3801 Stone Way N Seattle, WA 98103

*Supplemental Package
Design Recommendation Meeting
DPD #3014111
10.21.2013*

The developer and design team, working closely with the DPD, have made the specific revisions described and illustrated within this packet, in response to the Design Recommendations from the August 19th, 2013 DRB Meeting.

A. RESIDENTIAL ENTRY: WOODLAND PARK AVE N

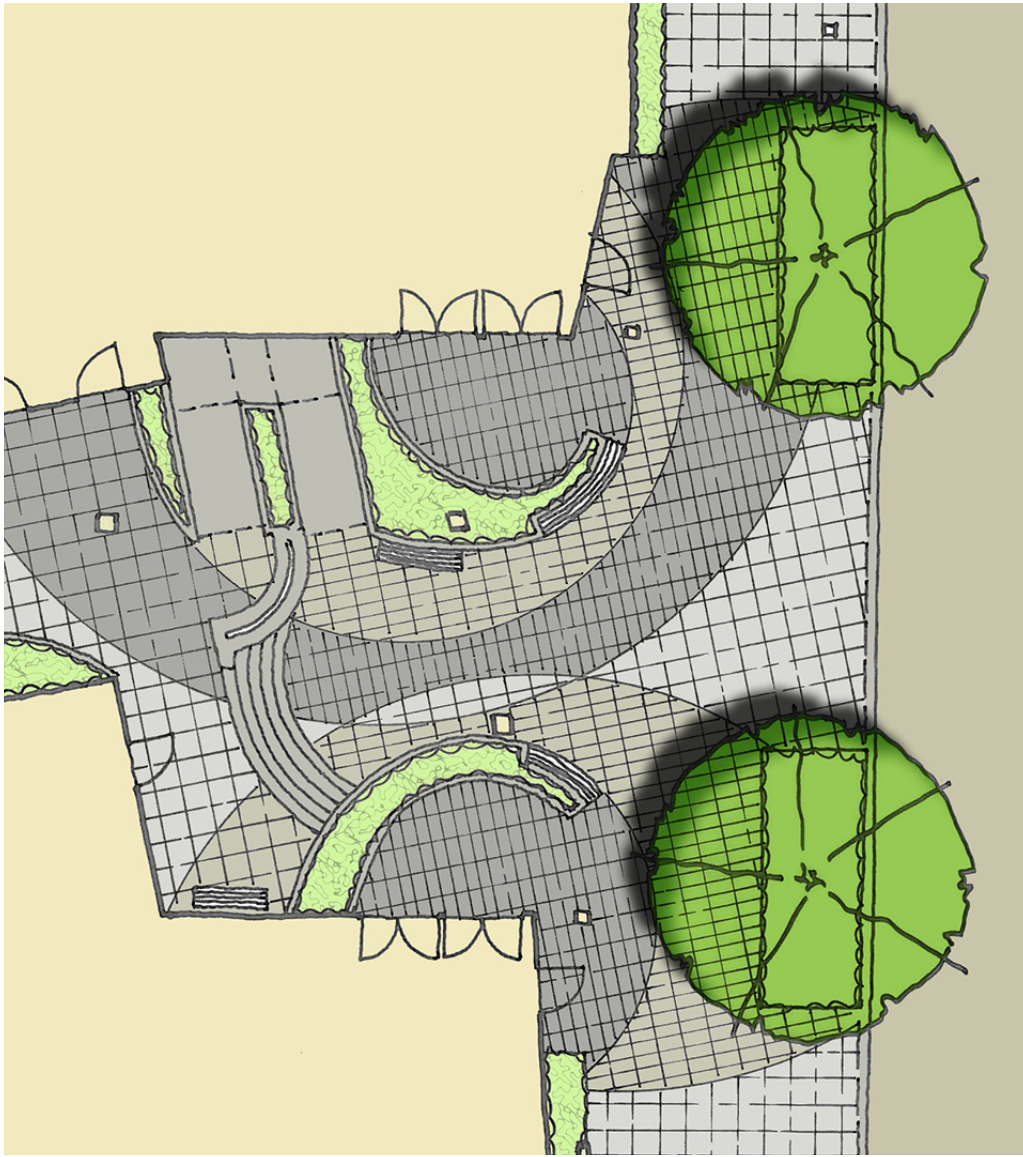
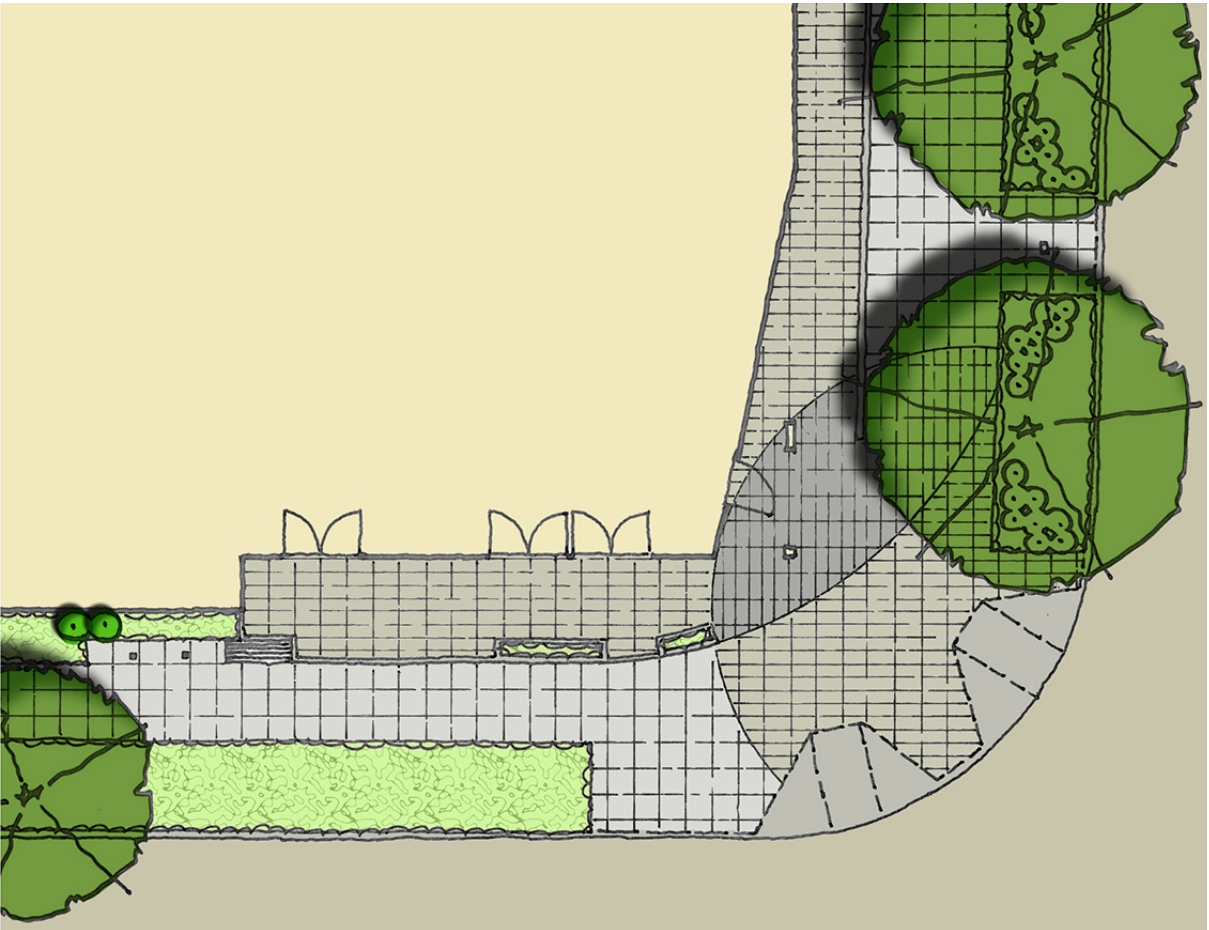
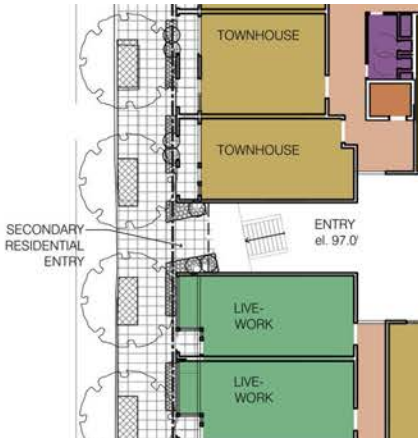
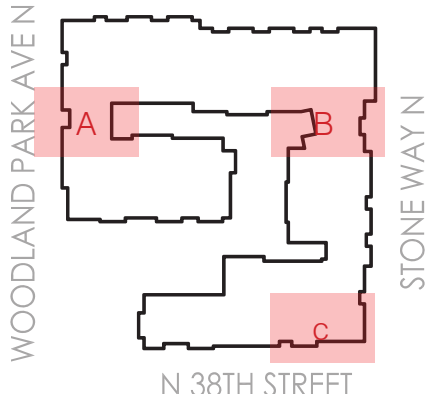
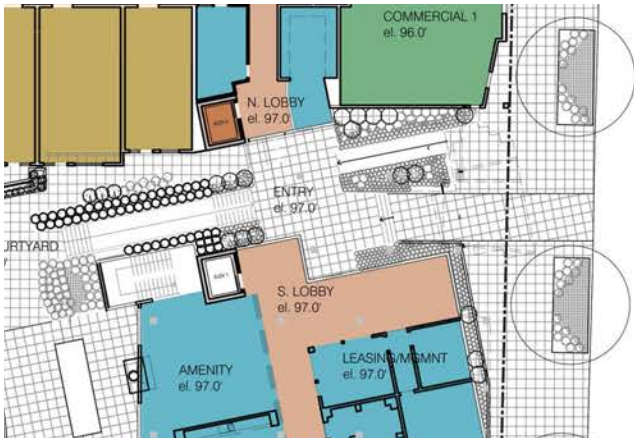
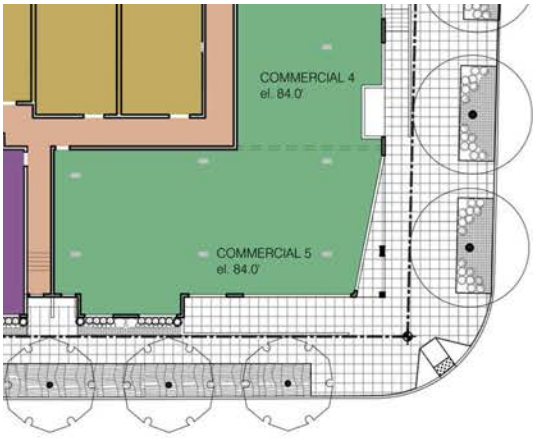
"...continuous canopies were not a necessity rather the architect should increase the depth of the canopies to extend into the rights of way when they do not interfere with the existing street trees..."
In response to Design Guideline C-3, Human Scale
(Design Recommendation, 10/19/2013)

“...Add patterns and variations to the paving design along the rights of way to articulate entries, plazas and corners. Patterns, street identification markers, etc. on the ground plane will help imbue the project with a sense of place.”
